THE MARYLAND-NATIONAL CAPITAL PARK & PLANNING COMMISSION

MEMORANDUM

REVIEW TYPE: Site Plan Review
CASE #: 8-0338
PROJECT NAME: Greencastle Towns
APPLYING FOR: Approval of 27 Townhouses
Article 59-D of the Montgomery County Zoning Ordinance
ZONE: RT-8
LOCATION: Greencastle Road, 1,500 feet south of Robey Road
MASTER PLAN: Fairland Master Plan, 1997
APPLICANT: TC Greencastle, LLC (Robert LoPinto)
FILING DATE: June 5, 2003
HEARING DATE: ~~September 18, 2003~~ **weather postponement to October 2, 2003**

1. Grading and Retaining Walls and Stormwater Management

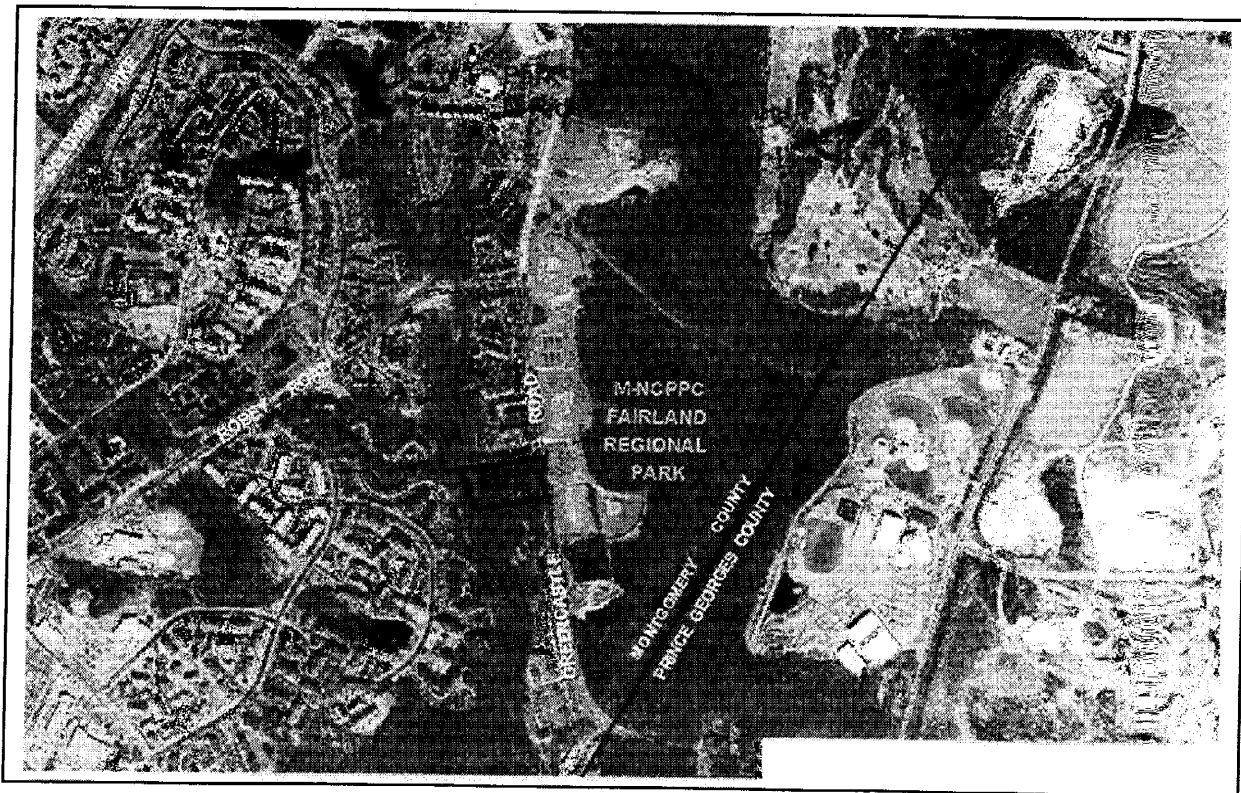
The shape and natural topography of this site along with the existing constraints of the Greencastle Road ROW on the east and the stream buffer on the west create what is essentially an “infill” site that demands careful consideration of building locations, parking and adequate companion open space. Providing adequate parking for residents and visitors on this “tight” site presents additional challenges. The applicant’s original proposal featured surface stormwater management (SWM) treatment at the site’s center along with recreational amenities at or within the stream buffer area. The locations of the rear line of townhouse lots, consequently, rested within 30 feet of selected points of the stream buffer, a condition requiring extensive construction of retaining walls.

Applicant Position: The applicant’s revised design addresses the SWM facility design by providing underground water quality and quantity control. The retaining walls have been reduced significantly in length and height. Formal recreational amenities have been relocated out of the stream buffer areas.

Example: The original submission features approximately 487 linear feet of retaining walls, up to 10 feet in height, while the revised submission proposes about 220 feet of retaining walls with a maximum height of 4.3 feet.

Staff Recommendation: Staff recommends the applicant’s revised plan, which solves the problems inherent to the original submission. The placement of the stormwater underground provides clear open space that may accommodate adequate recreation at the site’s center. The houses located along the stream buffer have been shifted away from the steeper slopes of the stream buffer, which allows a reduction in the size and scale of the retaining walls, and their consequent impact on this environmental setting.
